Flats 1 to 5 Library Court, 391 High Road, Haringey, London, N17 6QN

Manufacturer Section Detail
Requirements GA

Drawing Nr.
12235-PR-LH_1-5-ZZ-DR-A-PLSK01

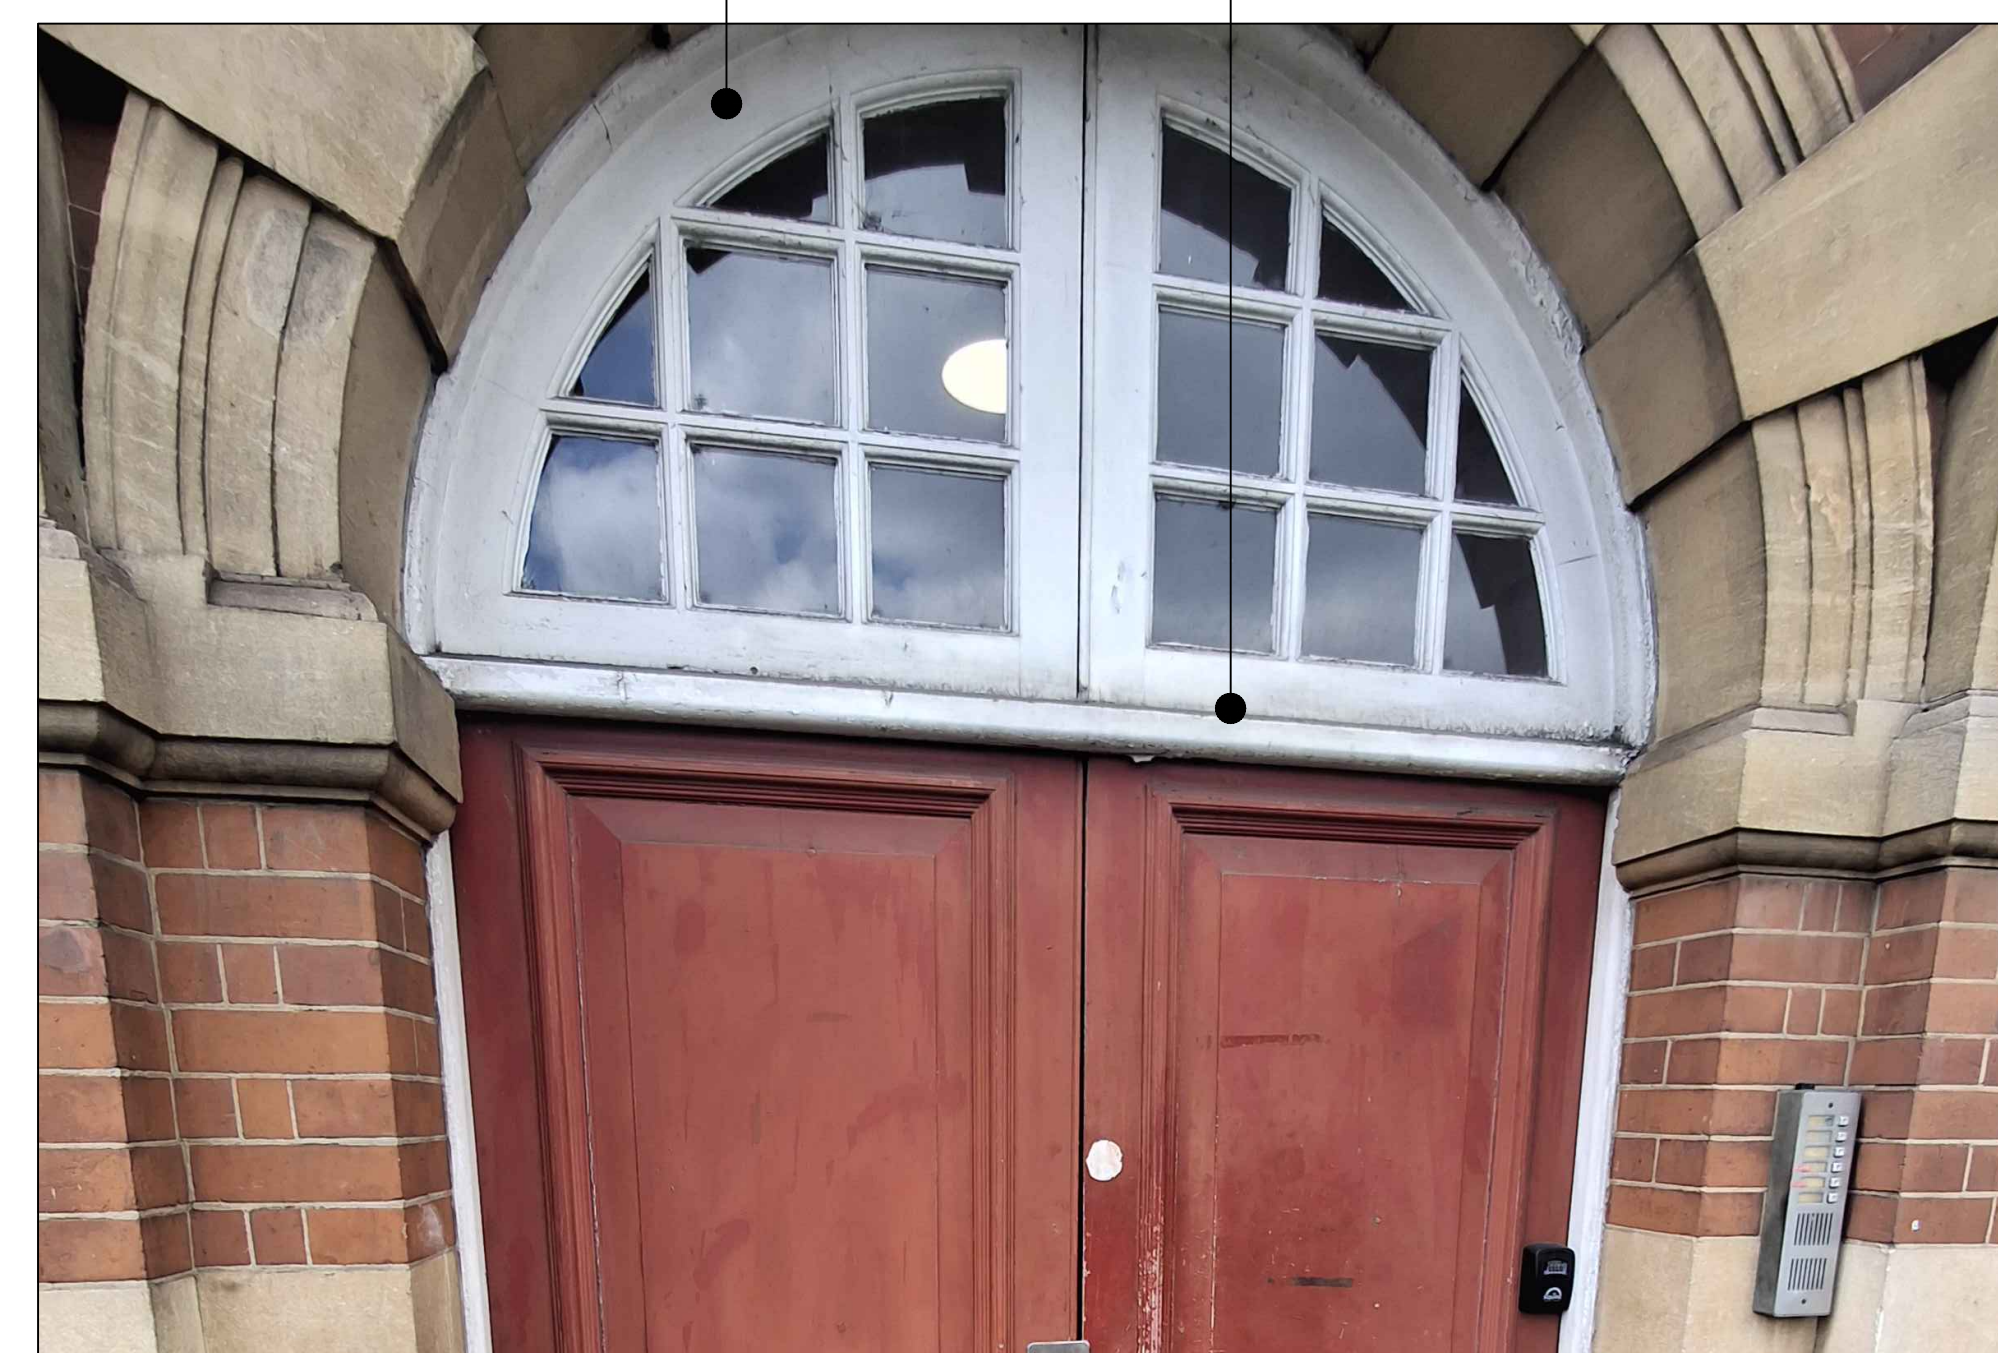
- These are standard size glazing bars which we have details for

— These are much larger glazing bars (of approx 45mm) which we don't have details for - they are shown on manufacturers quote sheets as larger but we need the section details for them.

This Arched outer frame is much larger than the others to the front elevation - we need the section details for this - see also all other section circled above. This outer frame also looks like a 'dummy sash' into an outer frame???

- What is the detail here when connecting to the head of the door that is not being replaced??? What is the weathering detail???
